Wake County Environmental Services
Water and Wastewater Section
ASP-075429-2022

Site plan reviewed as shown for:
Retaining walls

REVISIONS:	DATE: 01/26/2022	PRELIMINARY PLAT OF LOT 32 SOUTHERN HILLS ESTATES 1425 SKY VISTA WAY, RALEIGH		
	SCALE: 1"=40'			
	SURVEYED BY:	TOWNSHIP: BARTONS CREEK		
	DRAWN BY: JDF			
	CHECK & CLOSURE BY: JDF	COUNTY: WAKE		
	CAD FILE: LOT32SH			
	PROJECT NO: 02210215.00	STATE: NORTH CAROLINA		
		ZONE: R40W	P.I.N.: 0890132818	SHEET: 1 OF 2

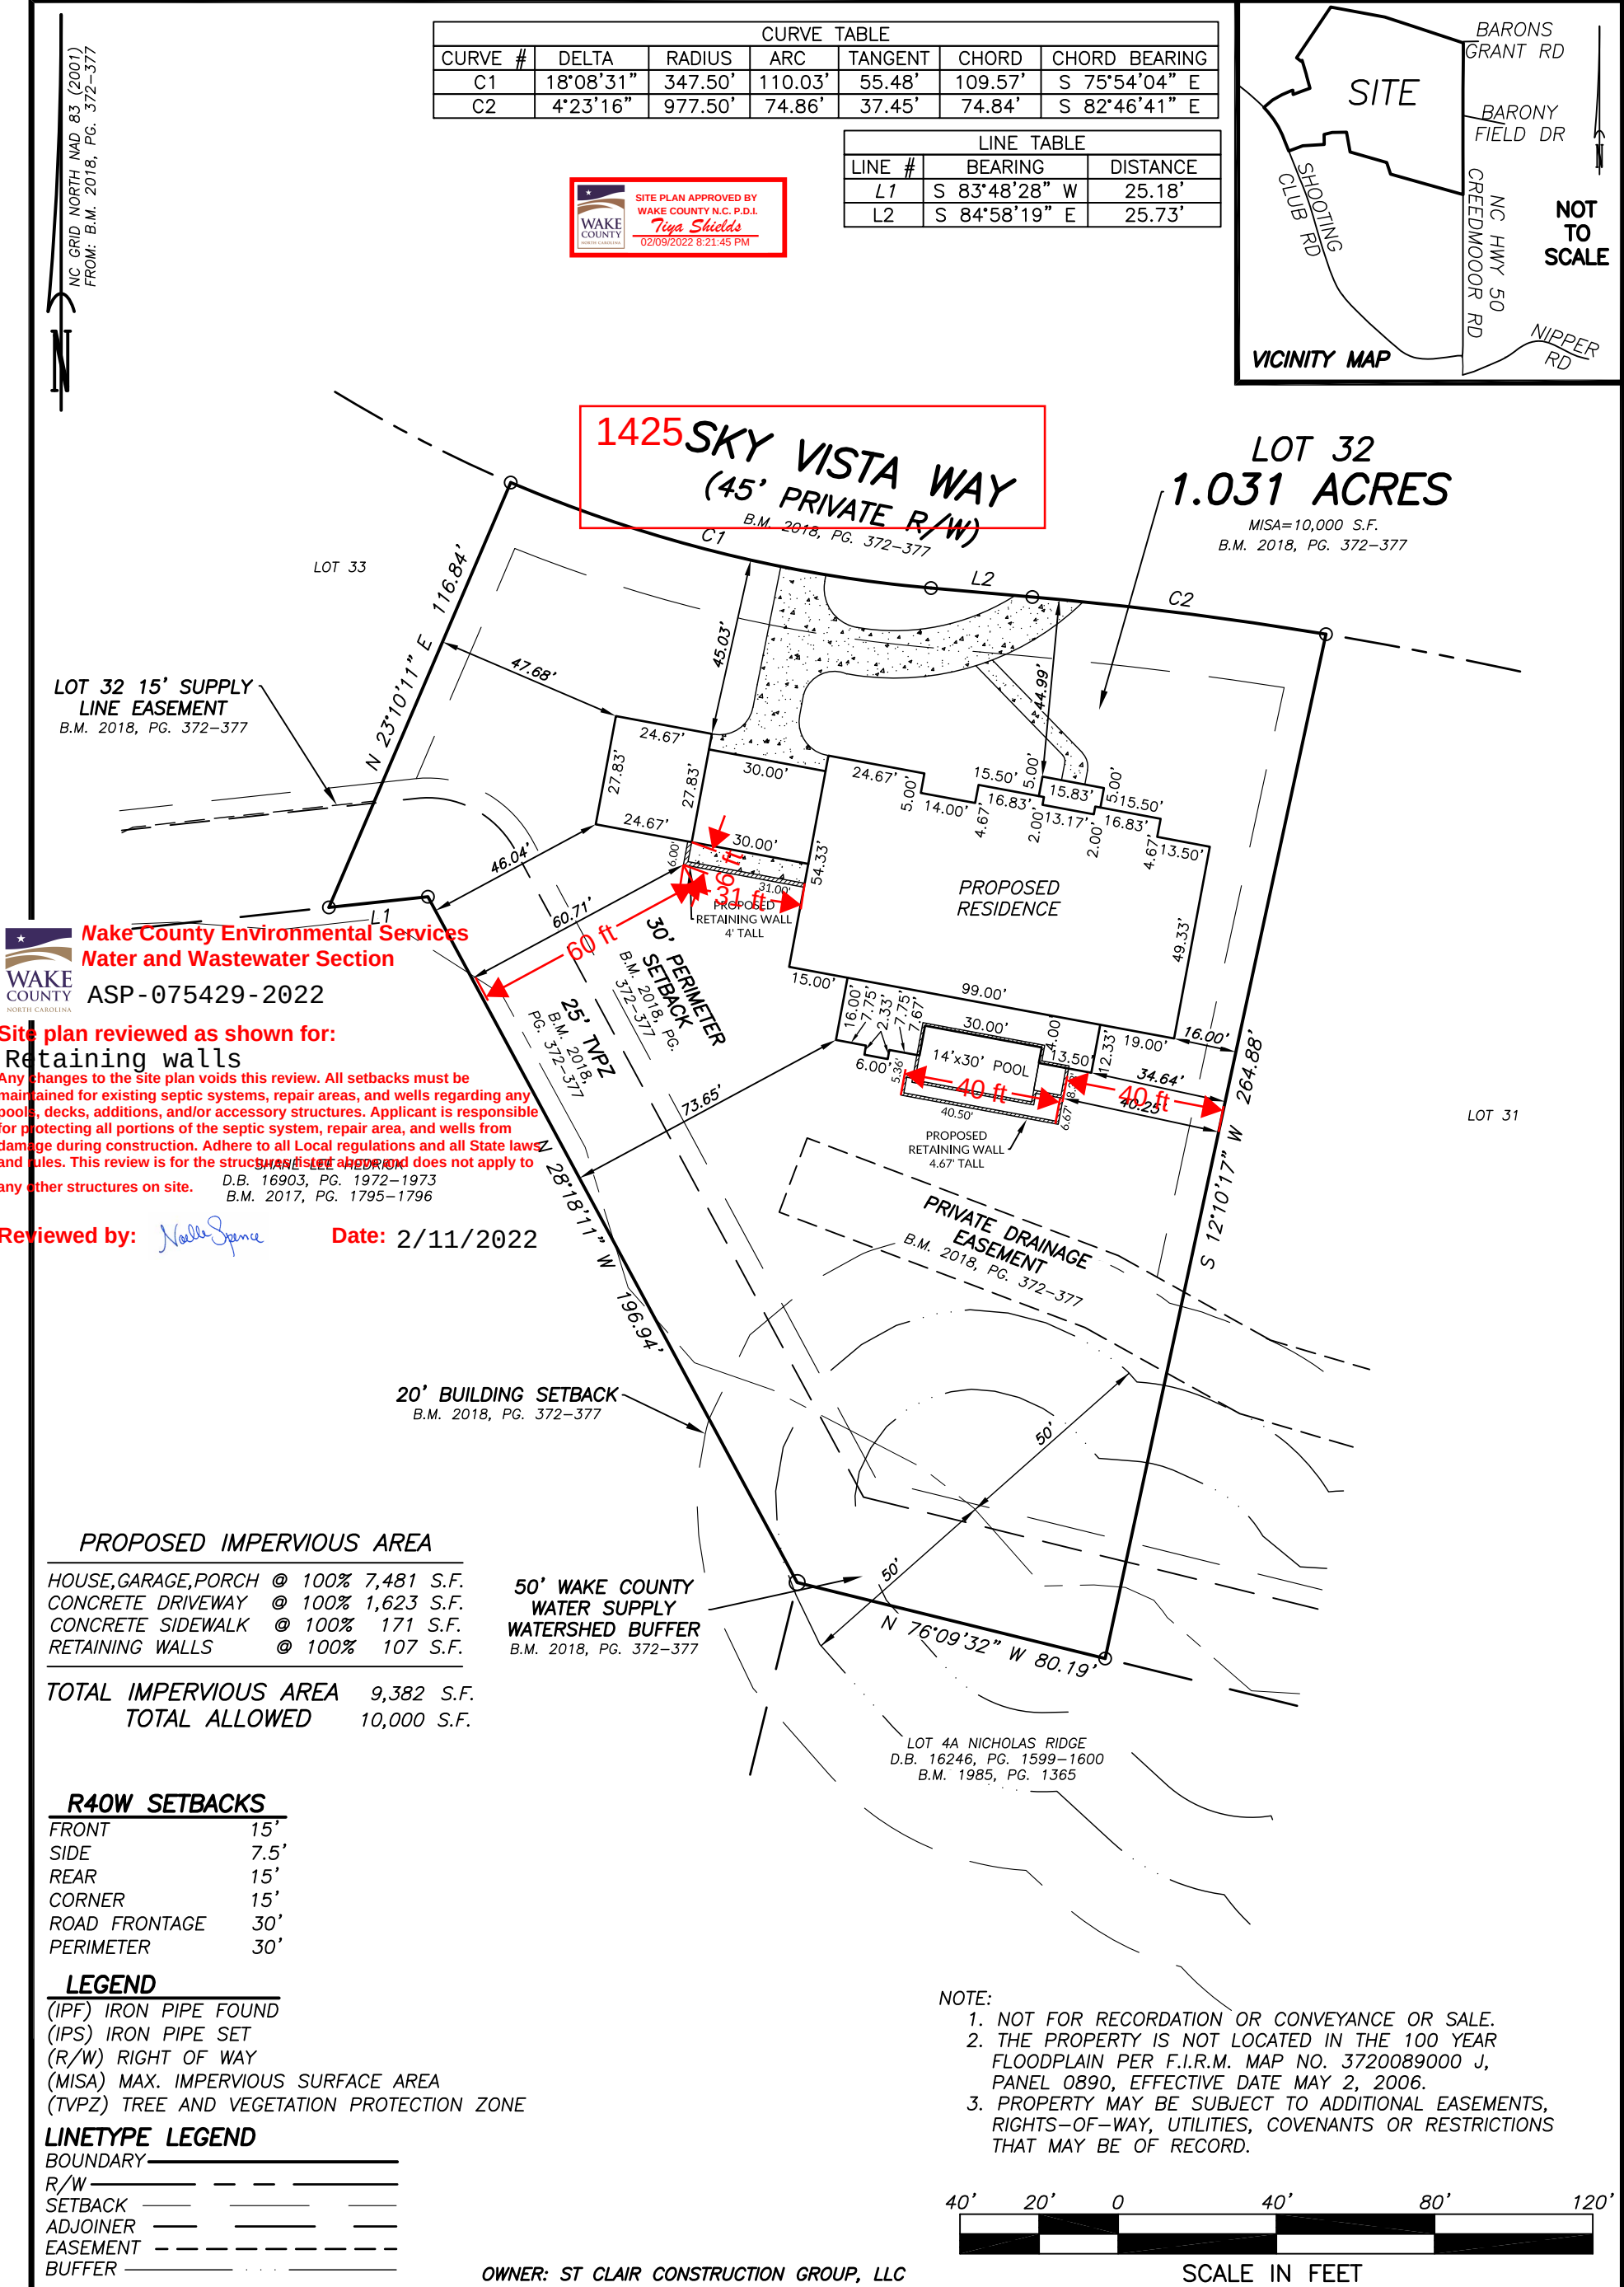
Any changes to the site plan voids this review. All setbacks must be maintained for existing septic systems, repair areas, and wells regarding any pools, decks, additions, and/or accessory structures. Applicant is responsible for protecting all portions of the septic system, repair area, and wells from damage during construction. Adhere to all Local regulations and all State laws and rules. This review is for the structural design and does not apply to any other structures on site.
